UNITED STATES PATENT AND TRADEMARK OFFICE

APPLICATION NO.	FILING DATE	FIRST NAMED INVENTOR	ATTORNEY DOCKET NO.	CONFIRMATION NO.
10/038,264	01/03/2002	Seungbae Park	EN999048D	8328

<b>Office Action Summary</b>	Application No.	Applicant(s)
	10/038,264	PARK ET AL. 
Examiner	Art Unit	
Ernesto Garcia	3679

## DETAILED ACTION

5,118,299

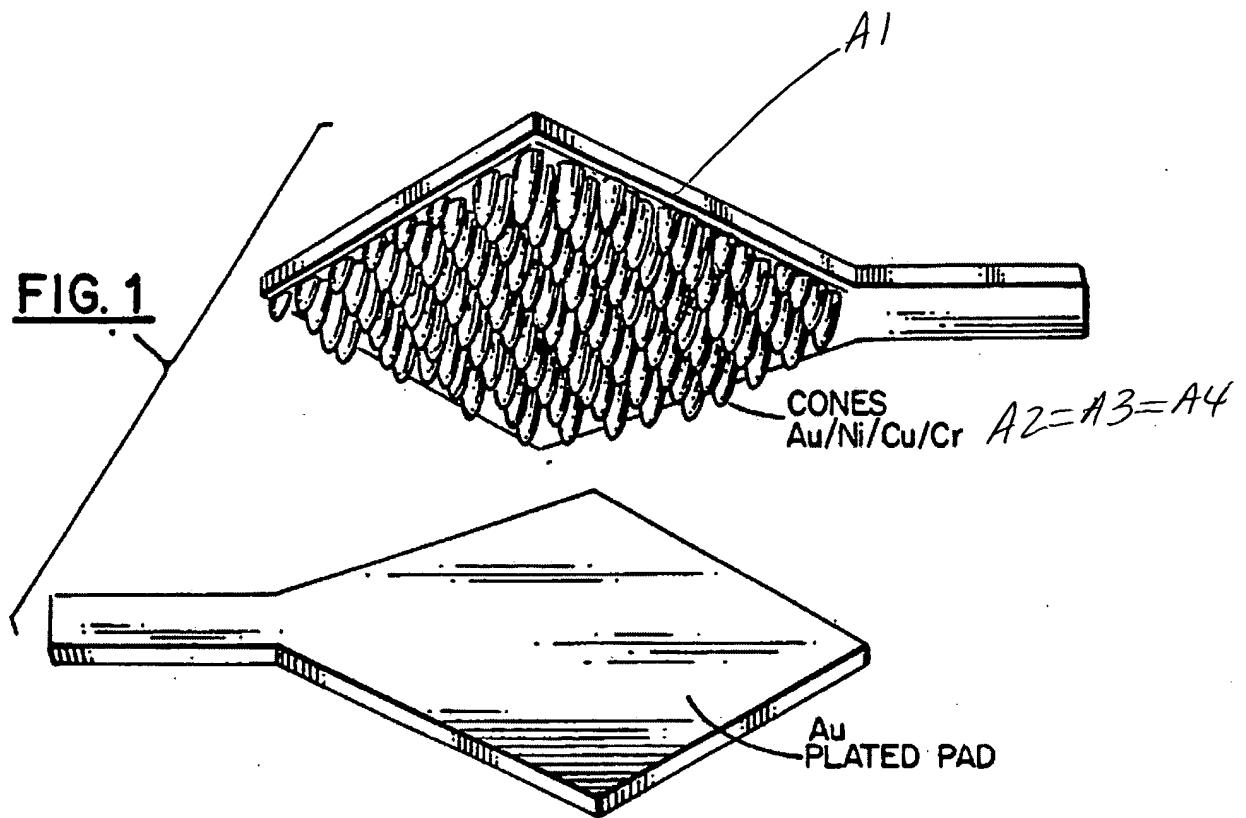
Claims 1 and 3-5 are rejected under 35 U.S.C. 102(b) as being anticipated by Burns et al., 5,118,299 (see marked-up attachment).

Regarding claim 1, the solder joint configuration comprising a pad **A1** having an irregular boundary layer **A2**.

Regarding claim 3, the solder joint configuration comprising a pad **A1** having an interdigitated boundary layer **A3**.

Regarding claim 4, the solder joint configuration comprising a pad **A1** having a curved boundary layer **A4**.

Regarding claim 5, the curved boundary layer **A4** further comprises a substantially continuous structure.
